Structural Special Inspections Report

**Portland Fire Department
Munjoy Hill Fire Station Monopole Replacement**

City of Portland Maine
July 24, 2012

CHECKED REINFORCING STEEL

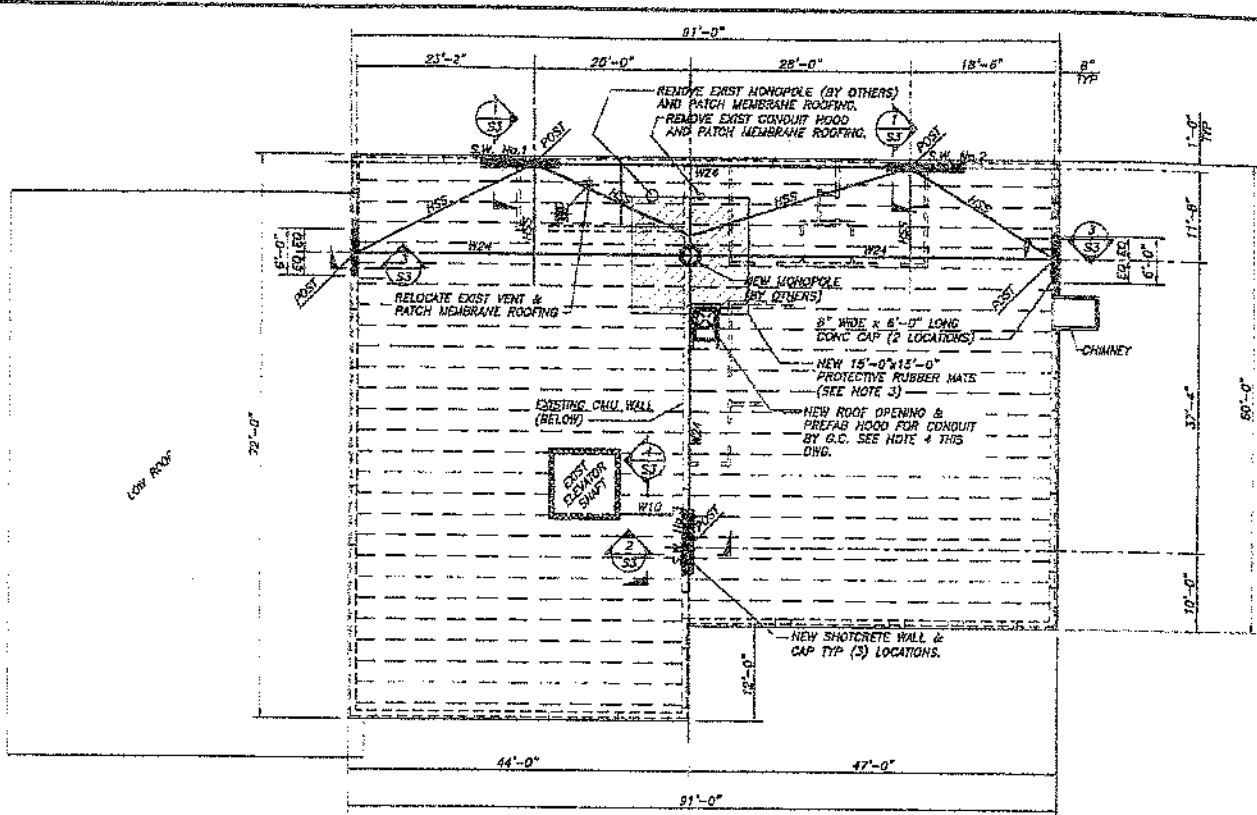
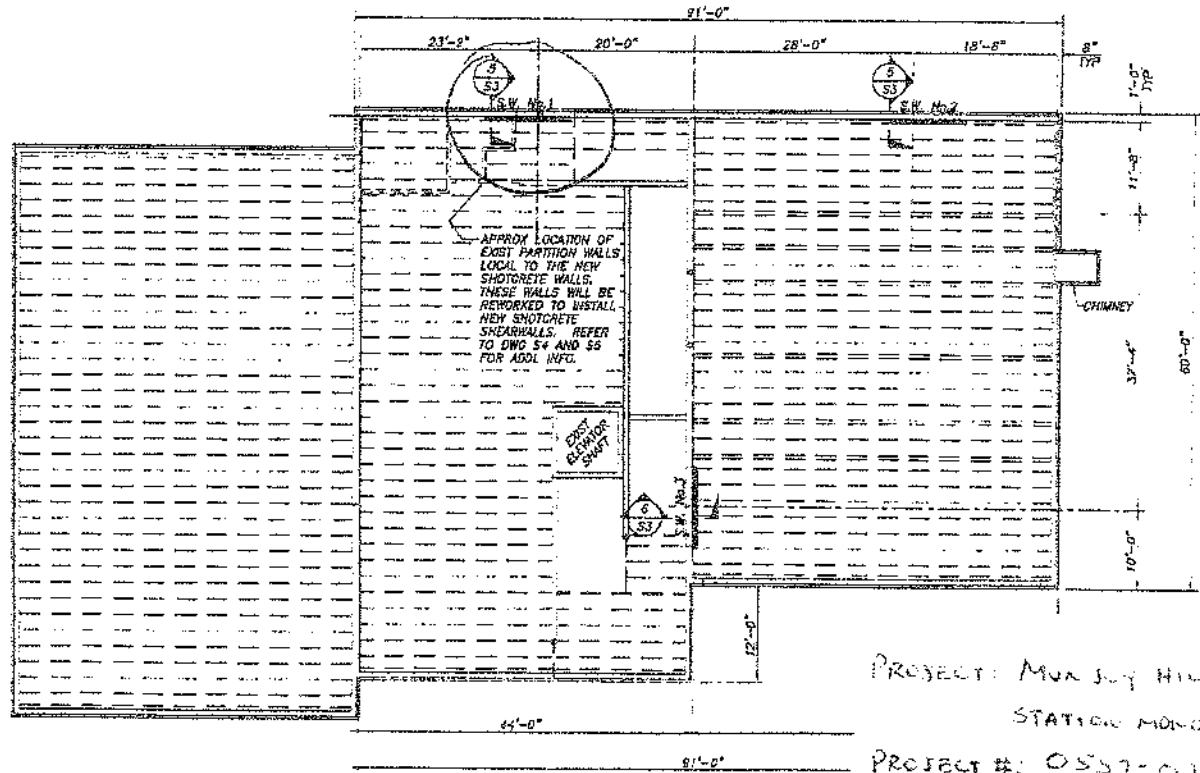
Visited the site in the afternoon to check the reinforcing steel for shotcrete walls No. 2 and No. 3 on the first floor. There was an area on wall No. 2 where Knowles used 2 # 5 rebar under the decking for the second floor rather than the specified # 7 rebar because the bends on the # 7 rebar caused the 2 pieces of rebar to protrude out too far to get coverage when shotcrete is to be placed. Travis (of Knowles) informed me that Bryson Welch (Becker Structural) had told him to replace the 2 # 7 rebar with 2 # 5 rebar due to clearance issues. The wall is also now 9'6" in width rather than the original specified width of 10', the amount of reinforcing steel in this wall did not change due to the change in width. The remainder of this wall was within project specifications. The reinforcing steel in wall No. 3 was checked and there was a location on the right side of the electrical panel where the spacing of the dowels exceeded the required 2'. I informed Travis (Knowles) and he said that they would correct this. There was also an area below the electrical panel where the spacing of one dowel was relocated due to the electrical lines inside the wall at the dowel location, all other areas of the wall were within project specifications.

PLACED SHOTCRETE

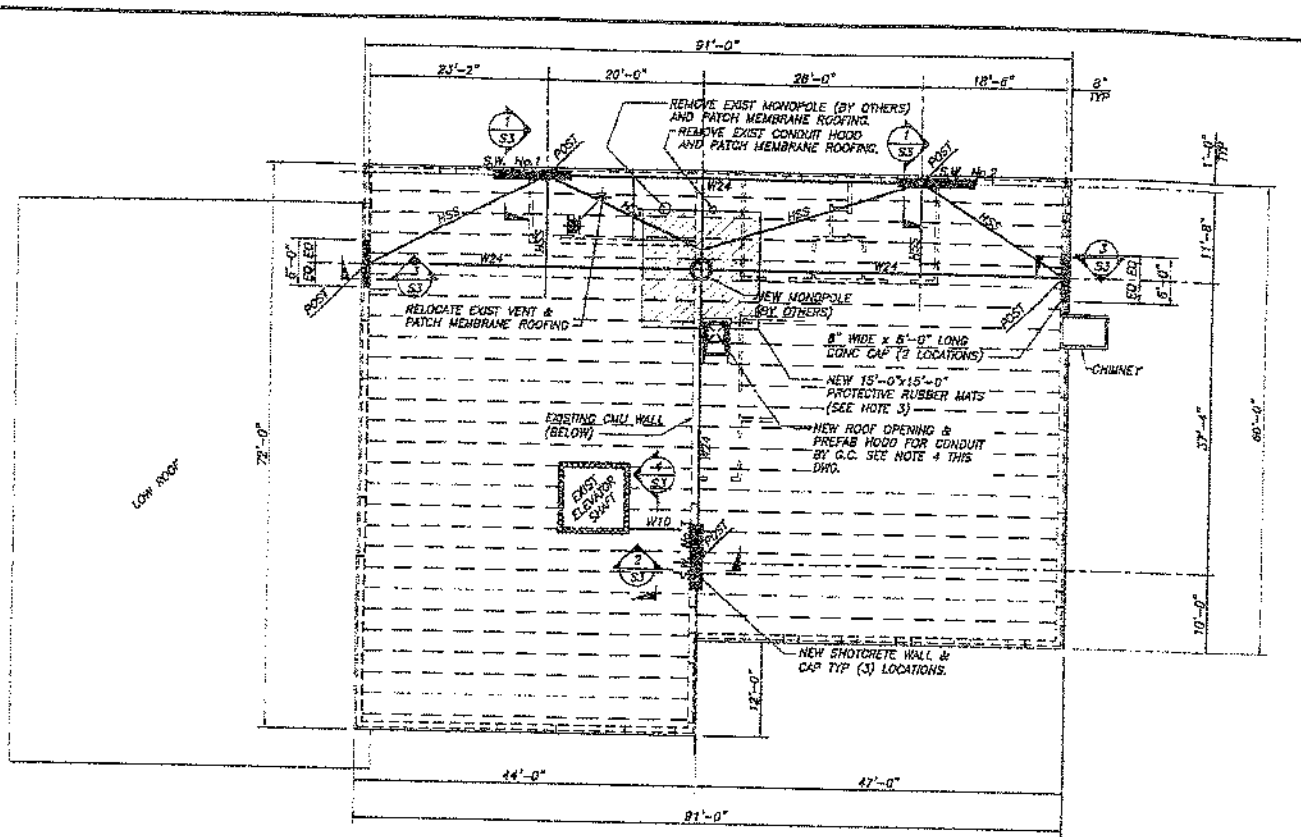
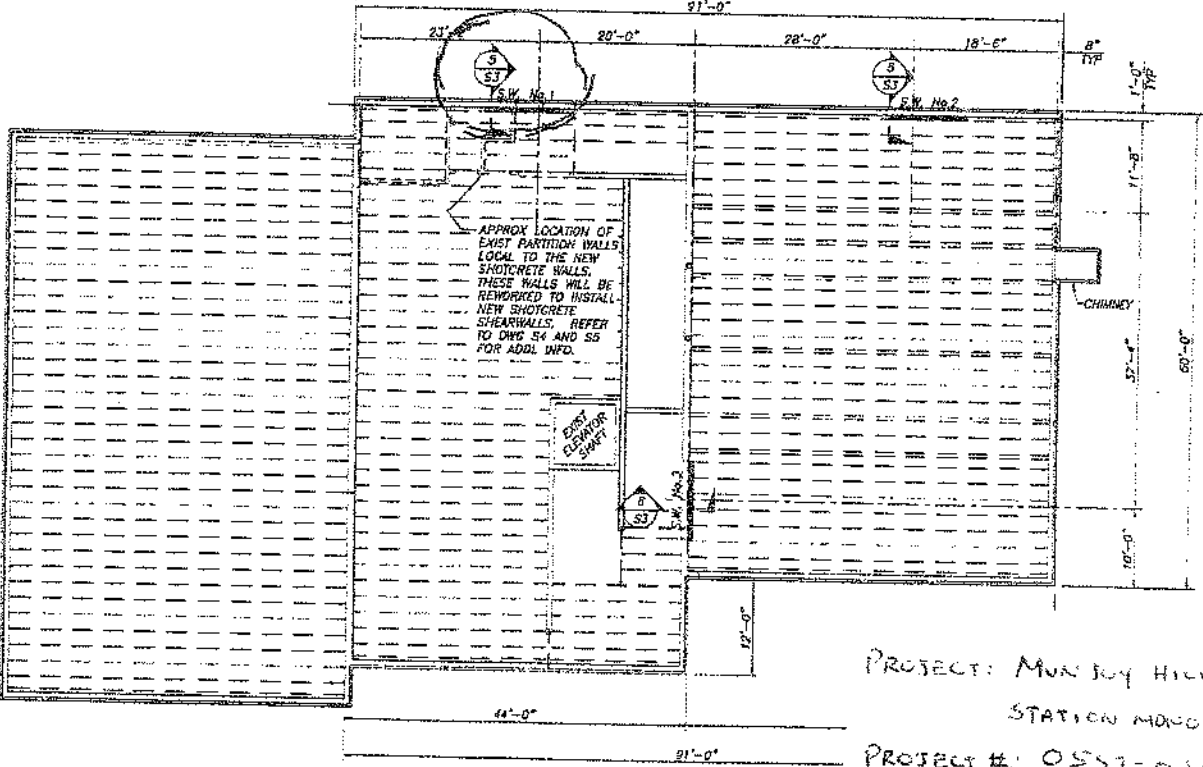
GOT TO THE SITE AND CHECKED THE REBAR FOR SHEAR WALL #2 THAT HAD NOT BEEN COMPLETED YET. ALL OF THE REBAR MET THE SPECS AND DRAWING'S ATTACHED KNOWLES MADE A 2'x2' PANNEL TO BE CORED TO TEST AFTER 28 DAYS I LEFT AFTER FIRST WALL WAS COMPLETED AND RETURNED THAT AFTERNOON TO OBSERVE THE SHEARWALL #2 BEING SHOTCRETED. REMAINED UNTIL END OF POUR. PANNEL WILL BE PICKED UP MONDAY (6/25)

CHECKED REINFORCING STEEL

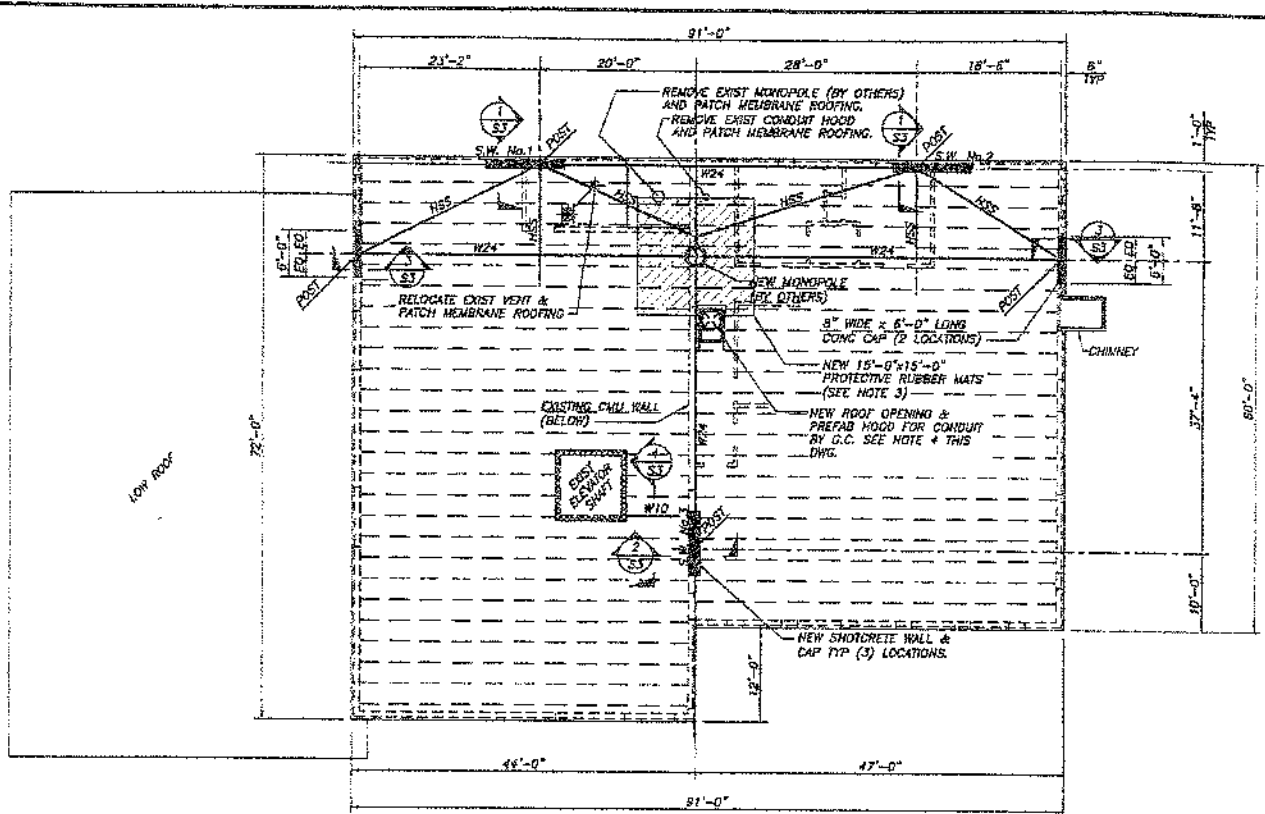
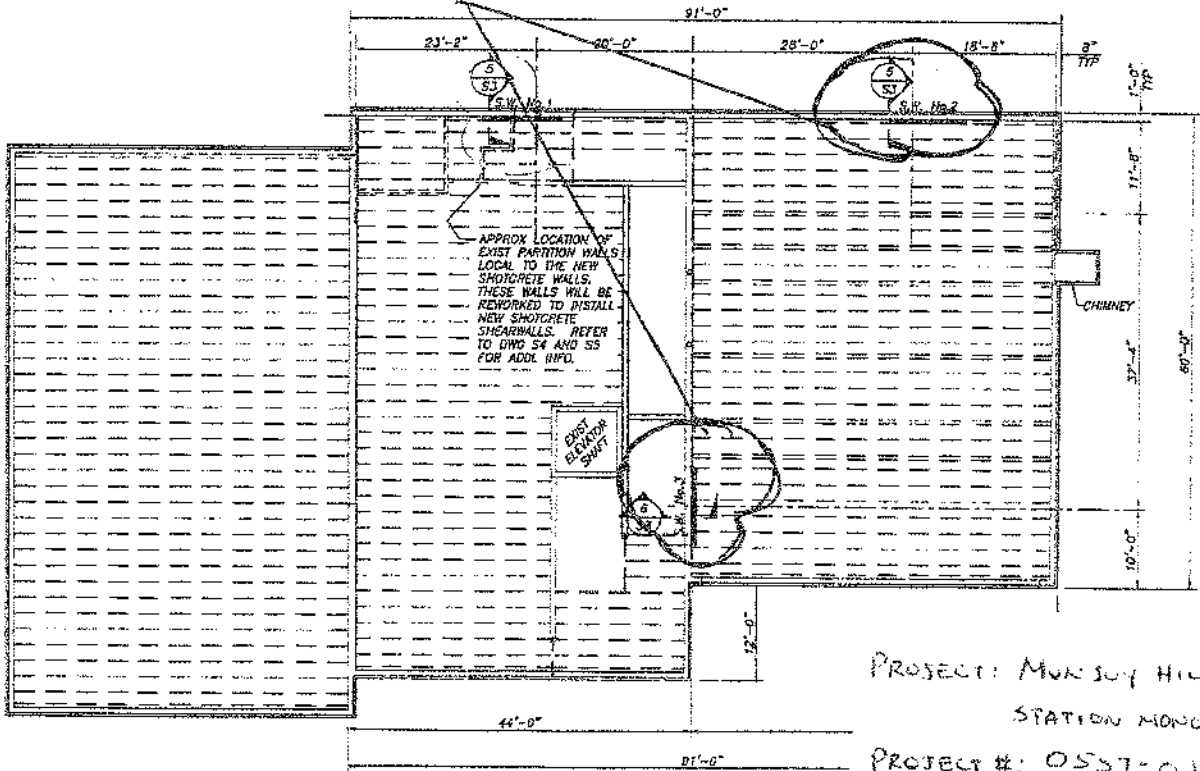
Visited the site in the afternoon to check the reinforcing steel for Wall No. 2 & Wall No. 3 on the second floor. When I arrived at the site Knowles Industrial Services Corporation were still trying the reinforcing steel for Wall No. 3, they had not yet finished installing the dowels in the wall and had not installed all the rebar at the top portion of the wall. Wall No. 2 was finished and was within general conformance with the project plans. Dan will finish checking the reinforcing steel for Wall No. 2 tomorrow morning when he arrives at the project.

Other: KNOWLES HAD NOT FINISHED TYING THE REINFORCING STEEL FOR WALL # 3. THEY WERE STILL INSTALLING THE DOWELS IN THE WALL AND THE REBAR HAS NOT BEEN INSTALLED AT TOP OF THE WALL

CHECKED BOLTED CONNECTIONS & WELDS

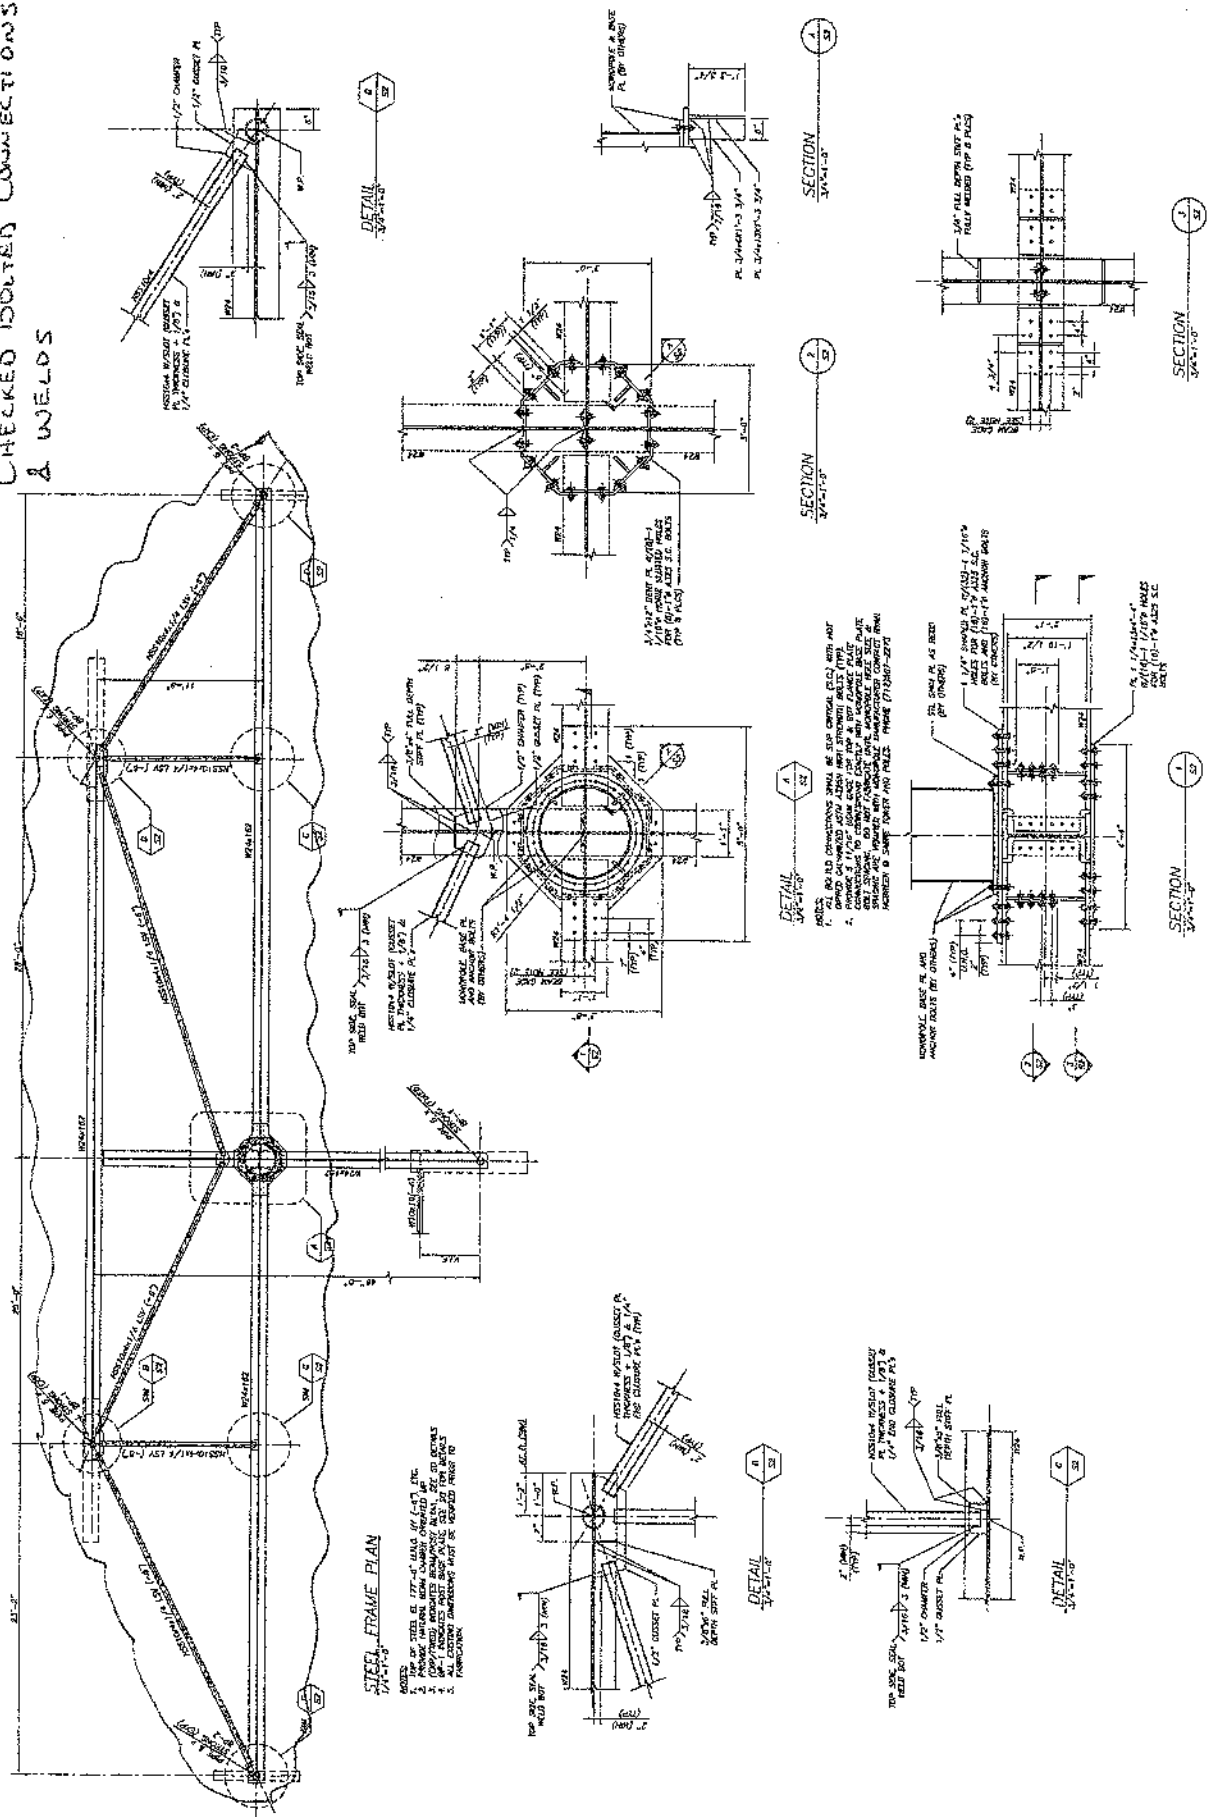
1. R.W. Gillespie contacted Becker to note that the welds connecting the washers to the post base plates did not conform to plans and specifications. While on site the condition and size of the welds were reviewed. After reviewing the design loads it was determined that the welds were acceptable as is.
2. New metal roof deck was not required therefore metal deck welds were not required.

3. The welder tack welded the two plates on top of the post together while welding to provide a ground. It was noted to the contractor and they will grind the weld out. It was later confirmed that this was removed on a site observation performed on 7/13/12.

CHECKED WELDS ON PLATE WASHERS

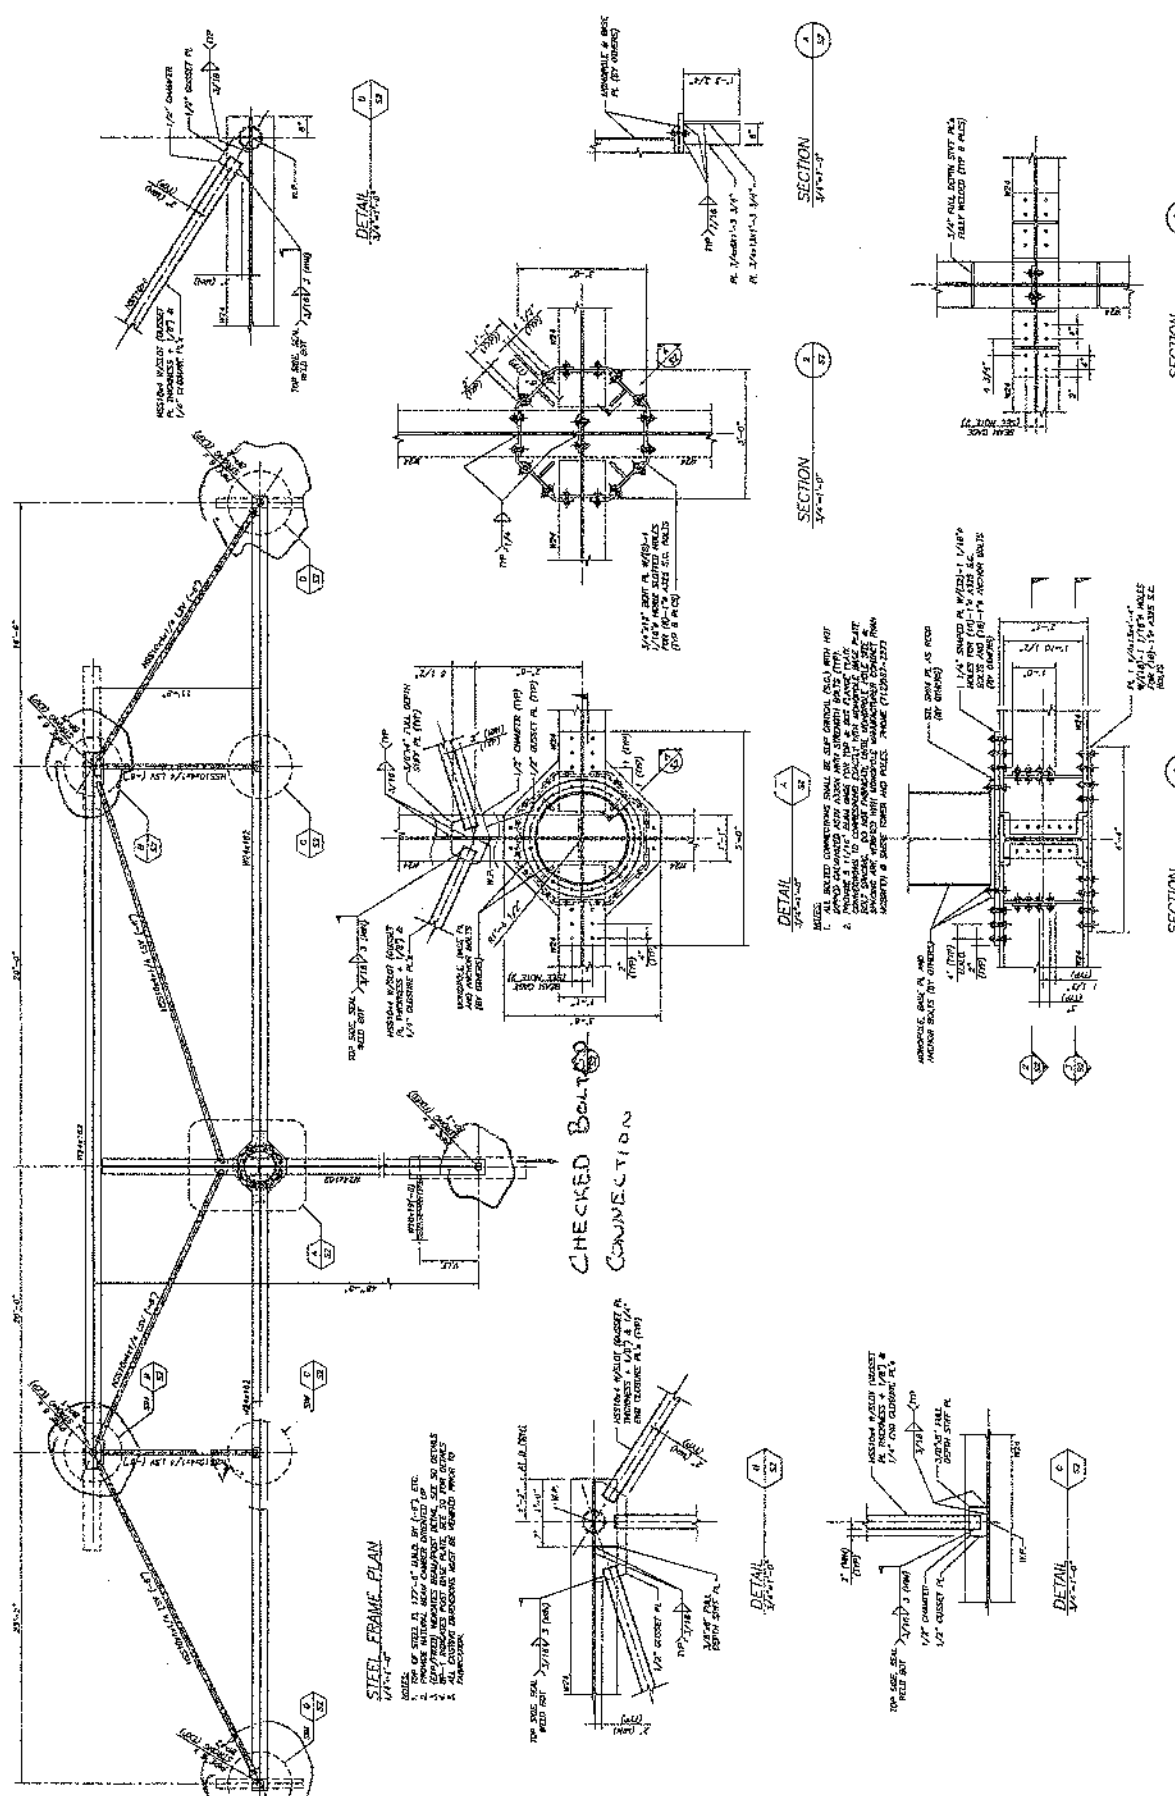
*Other: 07-11-2012 BRYSON ^{WELCH} CONTACTED ME AND INFORMED ME THAT HE HAD RECALCULATED THE LOADS AT THE CONNECTIONS WITH PLATE WASHERS THAT DID NOT CONFORM TO PLANS & SPECIFICATIONS. BRYSON SAID THAT AFTER COMPLETE CALCULATION THAT HE DETERMINED THAT THESE WELDS WOULD BE ACCEPTABLE. BRYSON HAD VISITED THE SITE TO LOOK AT THE WELDS HIMSELF.
